CENTURY PL Mounts on ARRICAM & 435 Advanced November 15, 2001

This note describes why Century PL mounts do not fit on the ARRICAM and 435 Advanced PL mount, and how to remedy this problem.

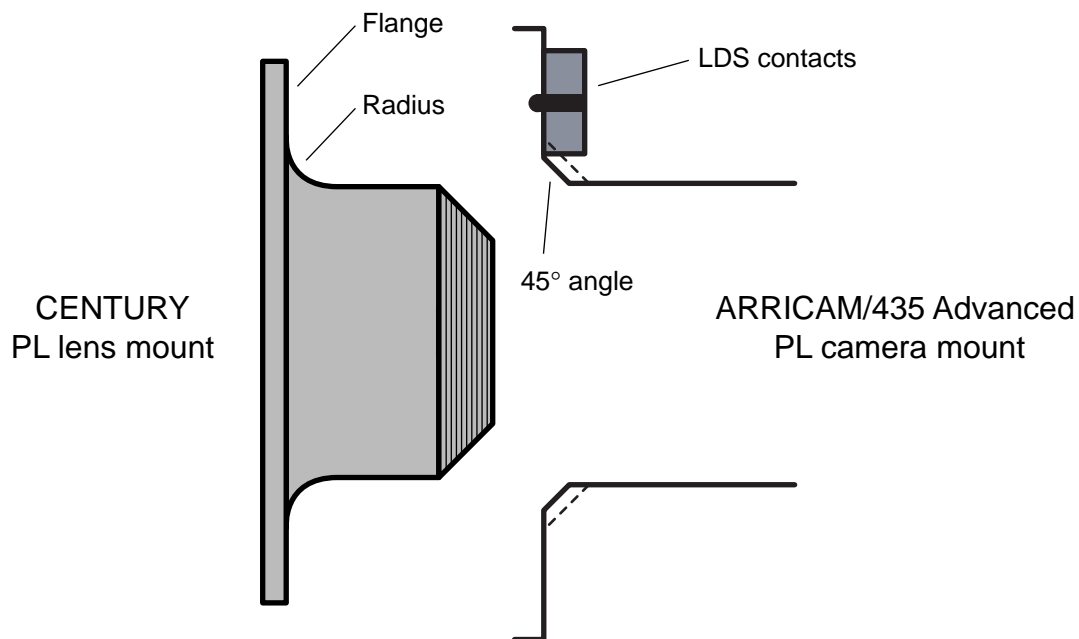
PL mounts manufactured by CENTURY Precision Optics cannot be mounted on PL mounts with LDS contacts used on ARRICAM and 435 Advanced cameras. It is not possible to insert the lens all the way into the camera's PL mount. This is also the case with CENTURY extenders.

Unlike Zeiss PL mounts, CENTURY mounts have a slight radius in the 45° angle behind the flange.

On ARRIFLEX cameras this doesn't cause a problem because the 45° angle on the camera PL mount (dashed lines in drawing) is deep enough to accommodate this radius.

On ARRICAM and 435 Advanced cameras this 45° angle had to be moved out to avoid interference with the LDS contacts. This makes it too shallow to accommodate the CENTURY lens mount radius.

We recommend to mill down the radius on all CENTURY PL mounts.
